Not Approved

MRN 04/24/2025

Amy Sherman
8915 W. Hawthorne
Wauwatosa, WI

Finished Basement
Floor Plan

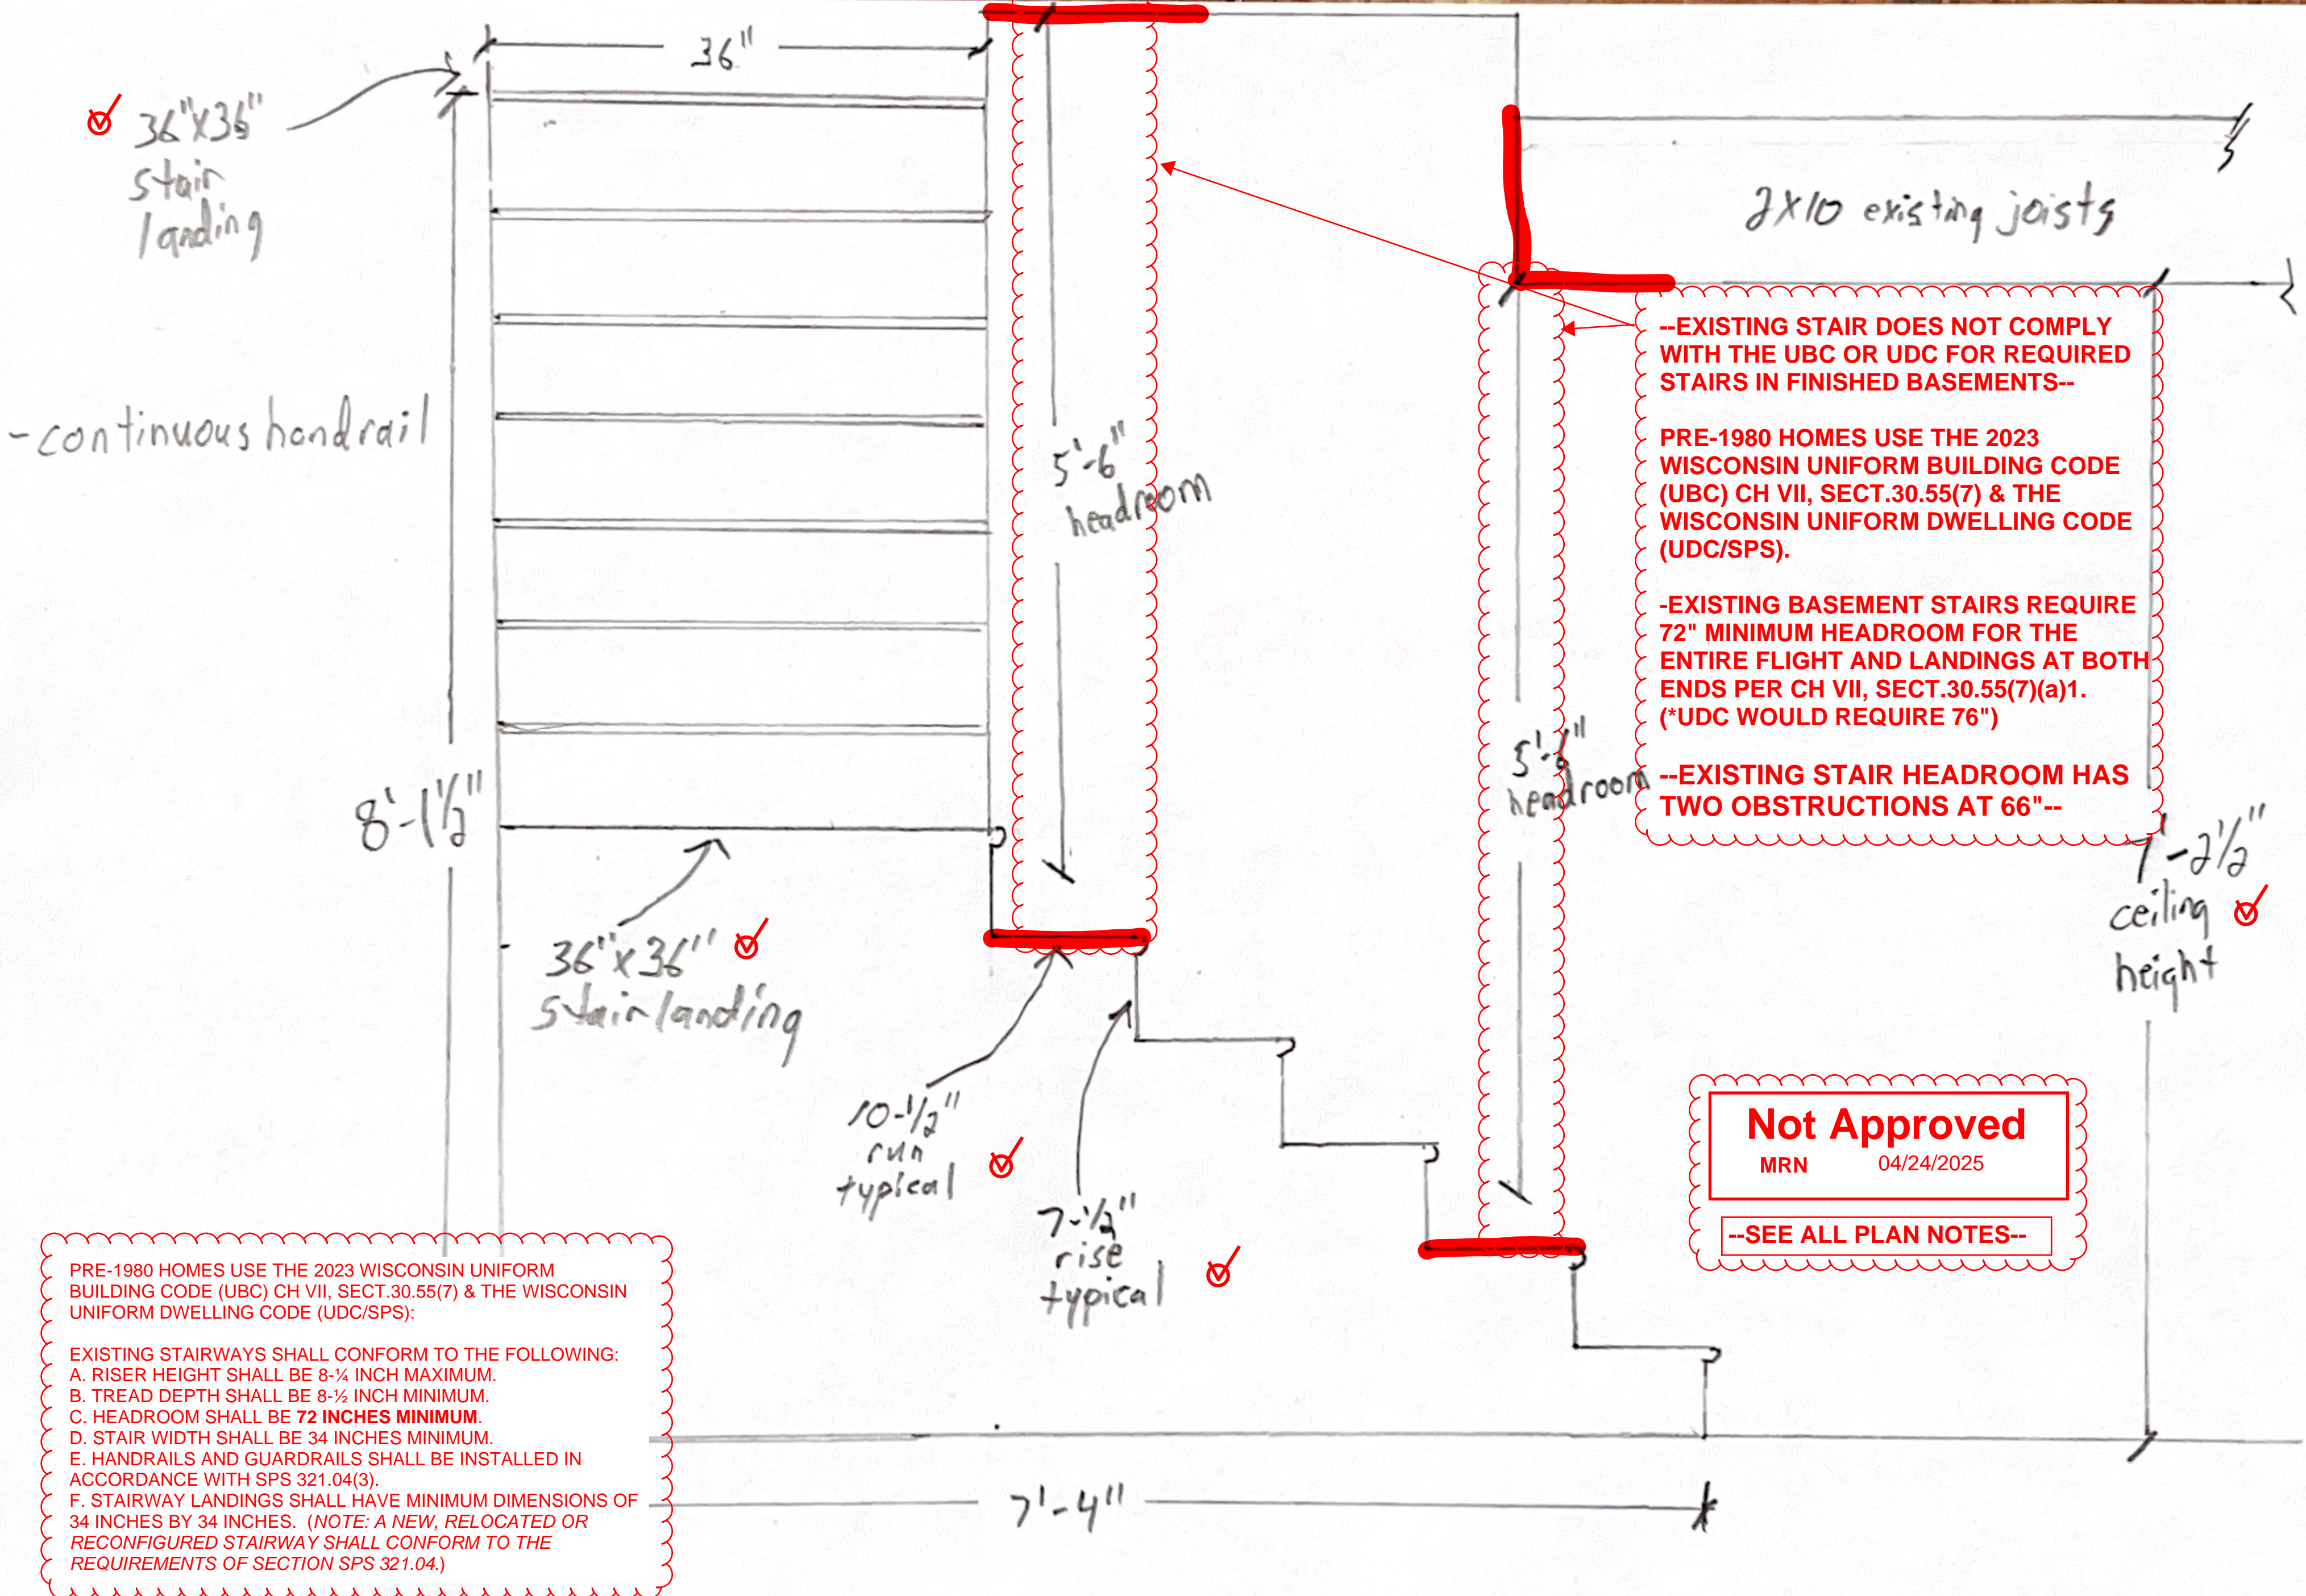
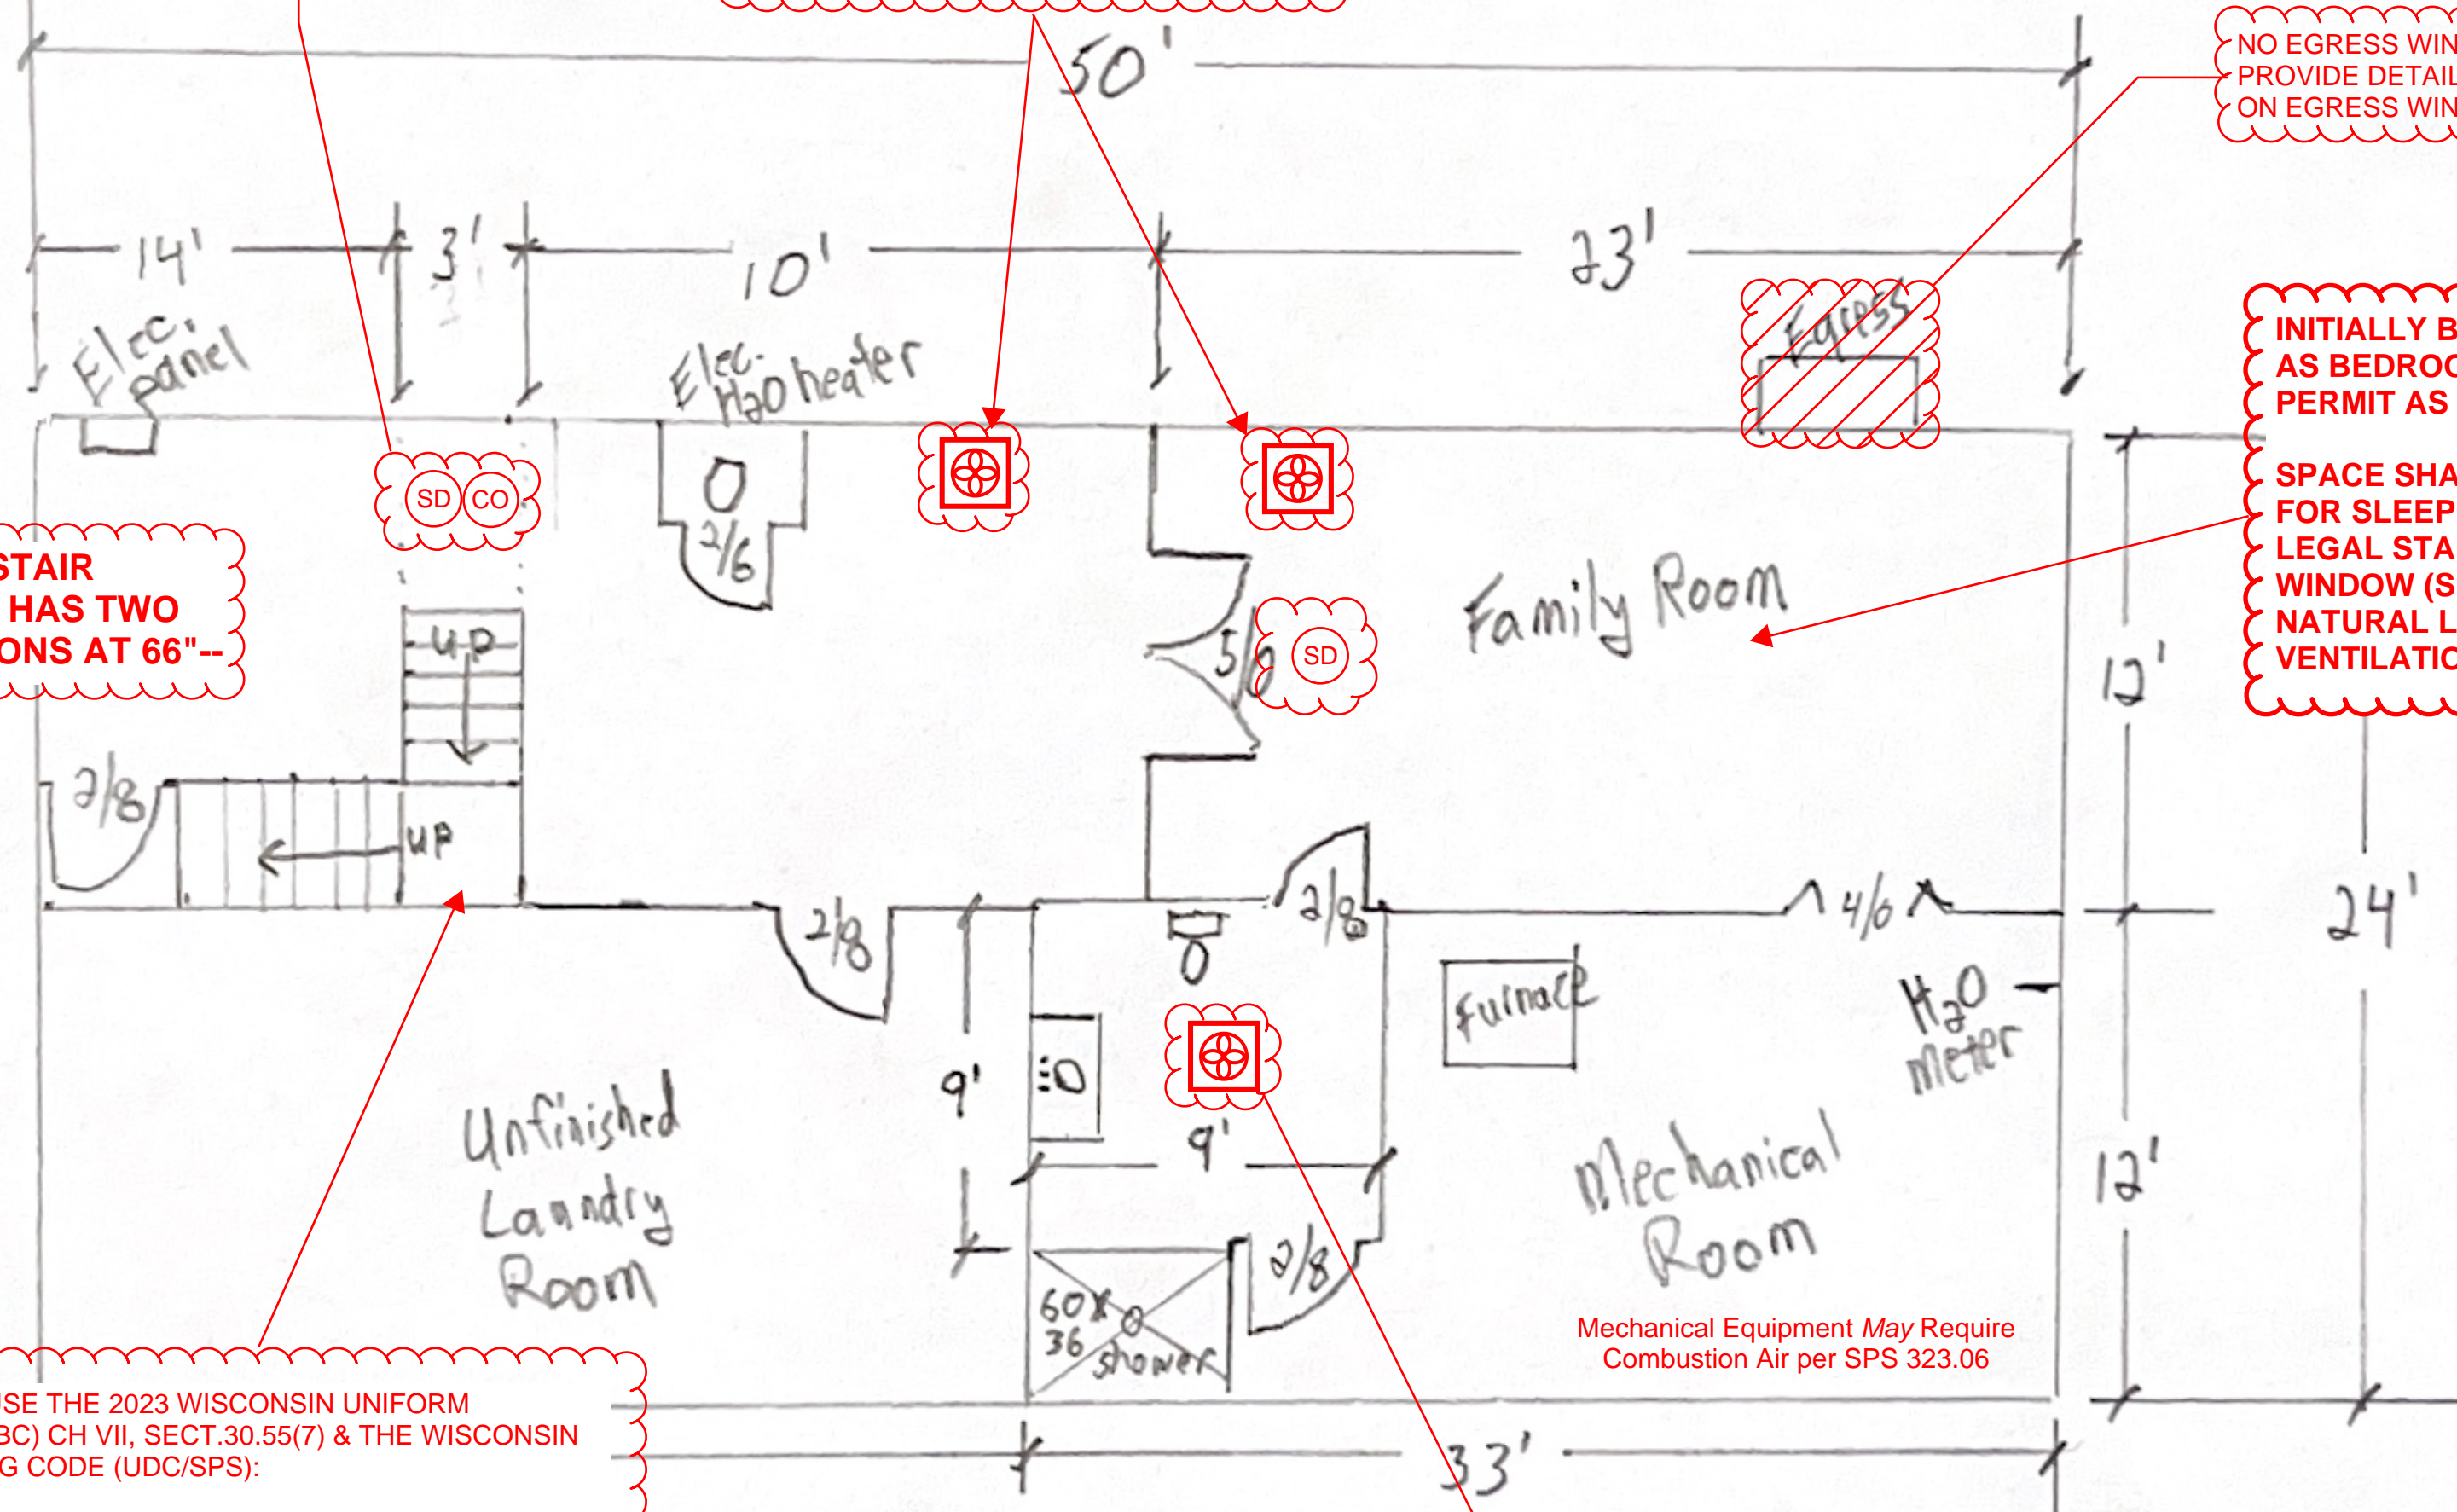
SMOKE & C/O DETECTORS
HARDWIRED AND
INTERCONNECTED IN ALL WORK
AREAS PER SPS 321.09 & 321.097

SHALL PROVIDE MECHANICAL VENTILATION
DUCTED TO THE EXTERIOR PER SPS
323.02(3)(c) AS NATURAL VENTILATION
CANNOT BE PROVIDED PER UBC
CH.VII,SECT30.55(7)2 AND SPS321.05

NO EGRESS WINDOW EXISTING,
PROVIDE DETAILED INFORMATION
ON EGRESS WINDOW AND WELL.

INITIALLY BUILT OUT AND SOLD
AS BEDROOM, SUBMITTED FOR
PERMIT AS REC-ROOM.

SPACE SHALL NOT BE USED
FOR SLEEPING WITHOUT
LEGAL STAIRS & EGRESS
WINDOW (SPS321.03(5)&(6)),
NATURAL LIGHT &
VENTILATION (SPS321.05)

**--EXISTING STAIR
HEADROOM HAS TWO
OBSTRUCTIONS AT 66"--**

BATHROOMS SHALL BE PROVIDED
WITH MECHANICAL VENTILATION
DUCTED TO THE EXTERIOR PER
SPS 323.02(3)(d)

Mechanical Equipment May Require
Combustion Air per SPS 323.06

PRE-1980 HOMES USE THE 2023 WISCONSIN UNIFORM
BUILDING CODE (UBC) CH VII, SECT.30.55(7) & THE WISCONSIN
UNIFORM DWELLING CODE (UDC/SPS):

EXISTING STAIRWAYS SHALL CONFORM TO THE FOLLOWING:

- A. RISER HEIGHT SHALL BE 8- $\frac{1}{4}$ INCH MAXIMUM.
- B. TREAD DEPTH SHALL BE 8- $\frac{1}{2}$ INCH MINIMUM.
- C. HEADROOM SHALL BE **72 INCHES MINIMUM**.
- D. STAIR WIDTH SHALL BE 34 INCHES MINIMUM.
- E. HANDRAILS AND GUARDRAILS SHALL BE INSTALLED IN
ACCORDANCE WITH SPS 321.04(3).
- F. STAIRWAY LANDINGS SHALL HAVE MINIMUM DIMENSIONS OF
34 INCHES BY 34 INCHES. (NOTE: A NEW, RELOCATED OR
RECONFIGURED STAIRWAY SHALL CONFORM TO THE
REQUIREMENTS OF SECTION SPS 321.04.)

Exterior Wall

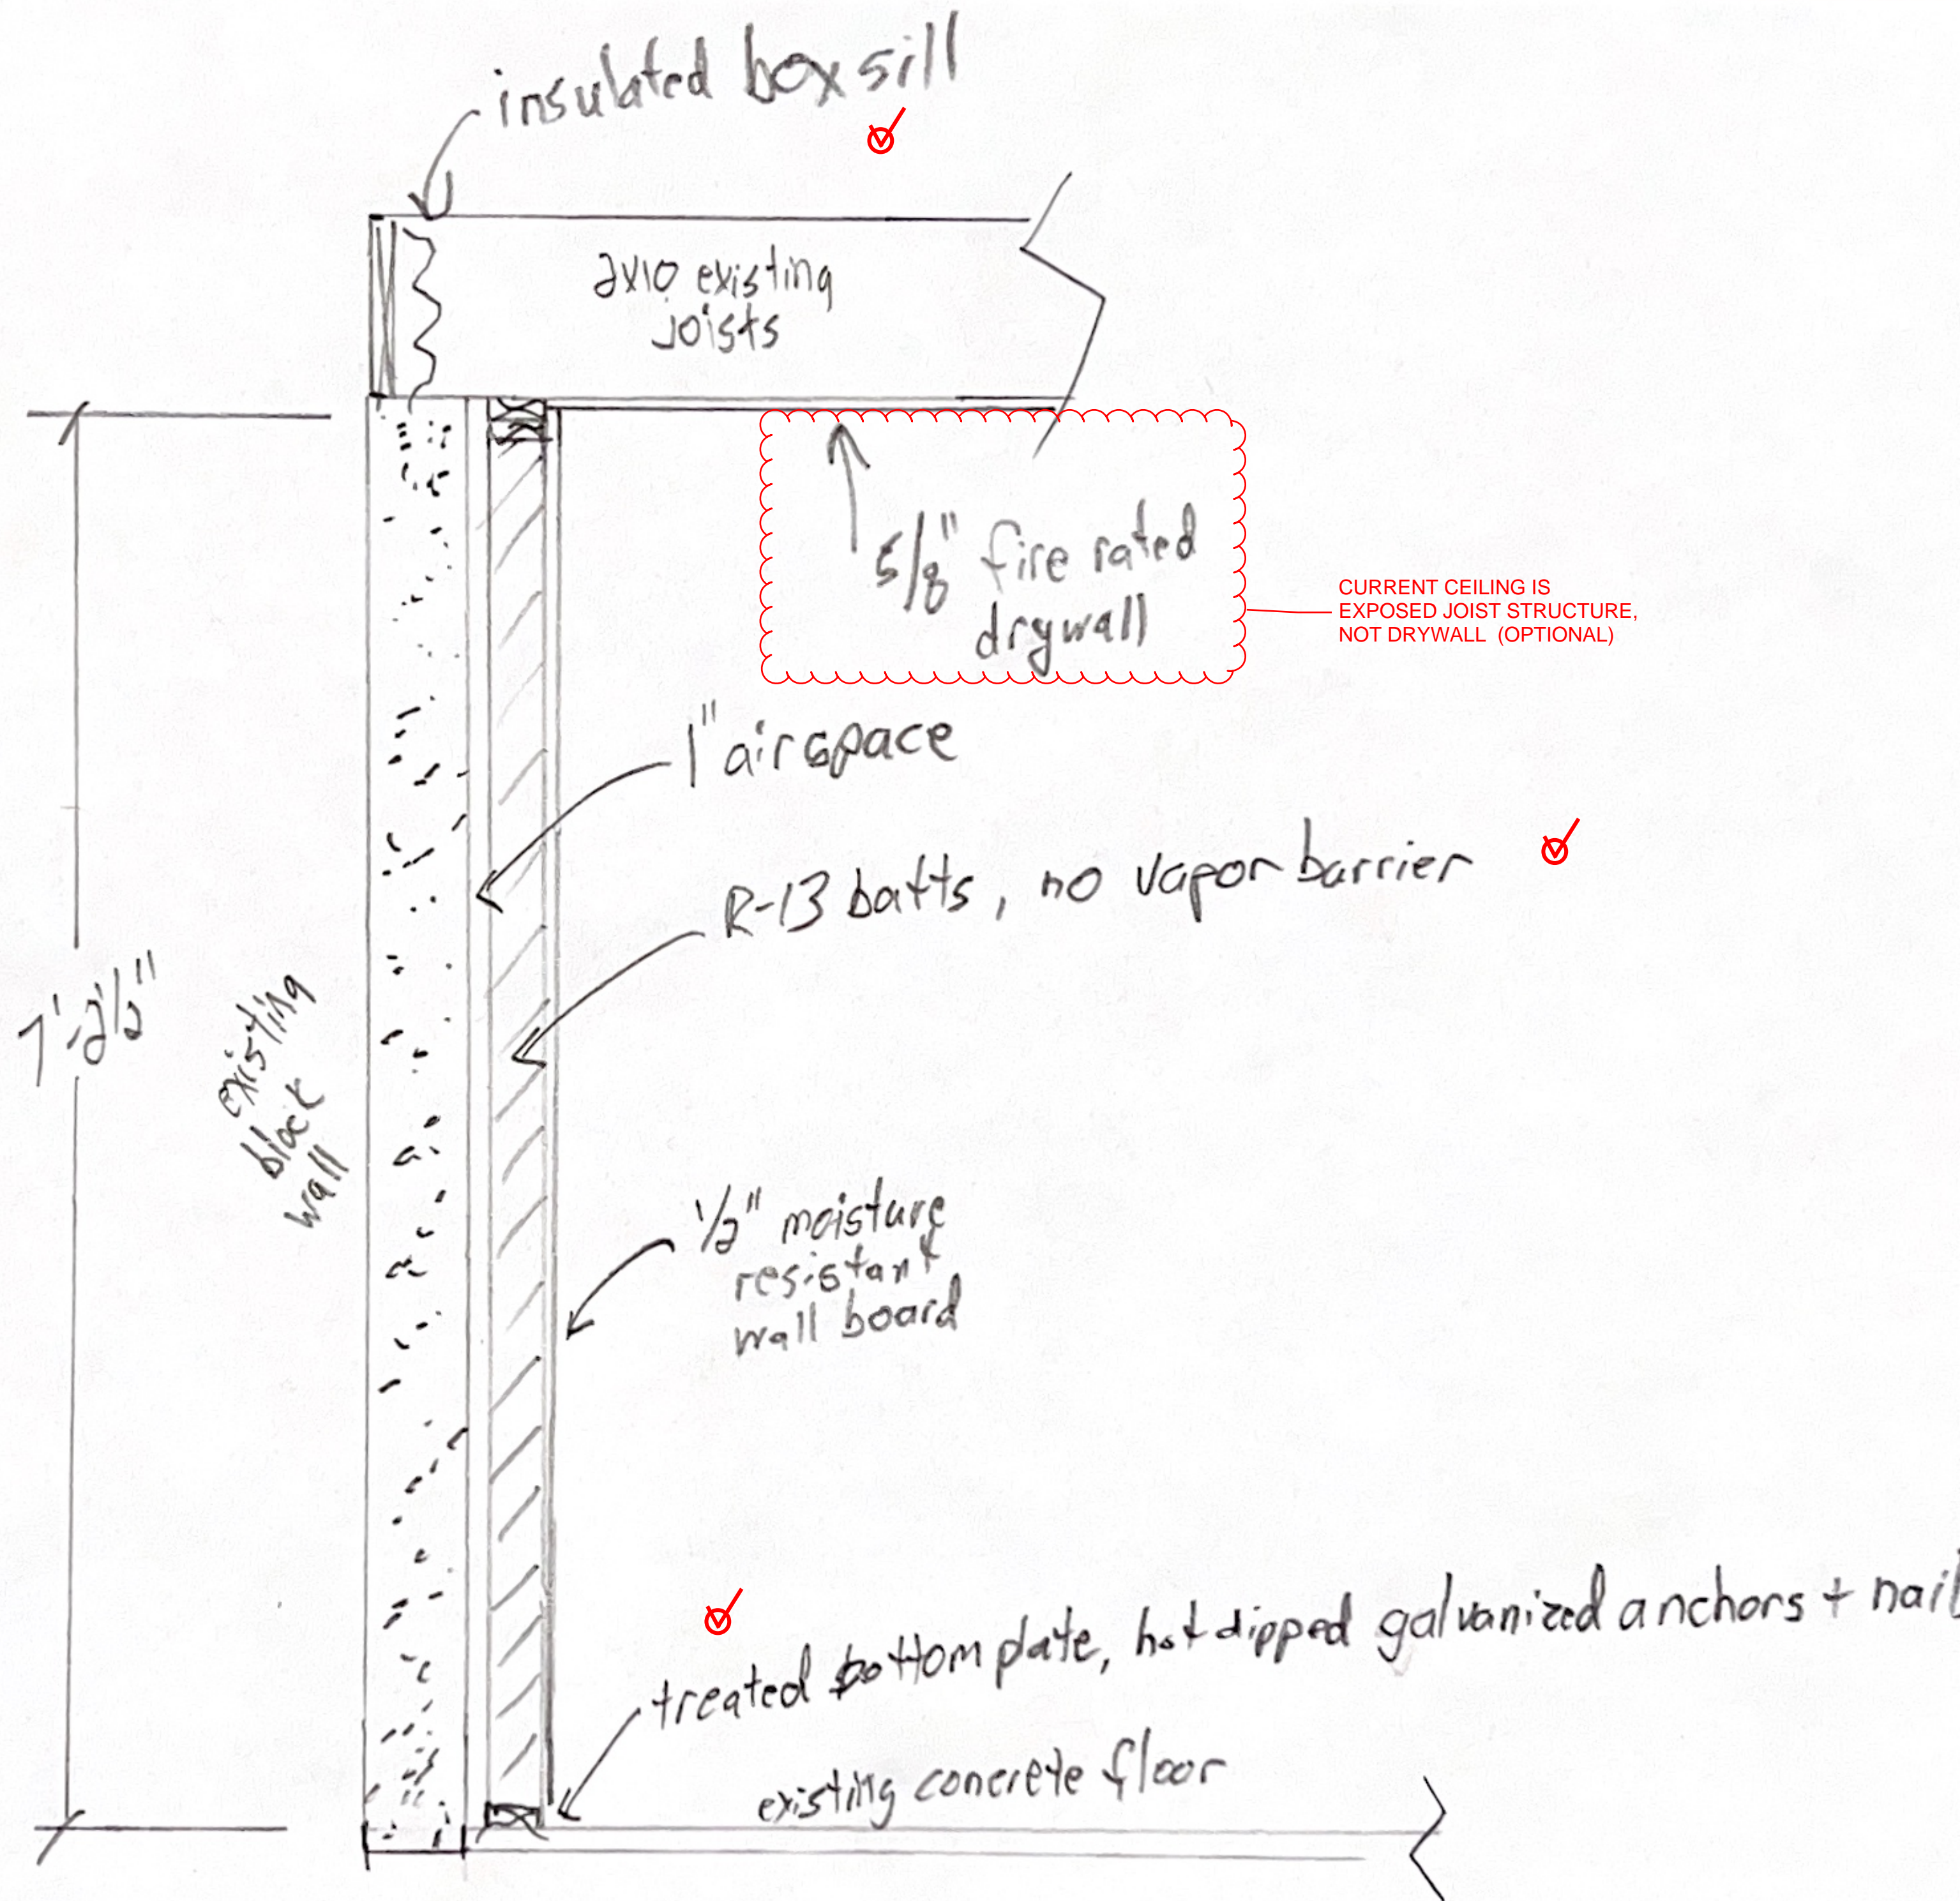
Not Approved

--SEE ALL PLAN NOTES--
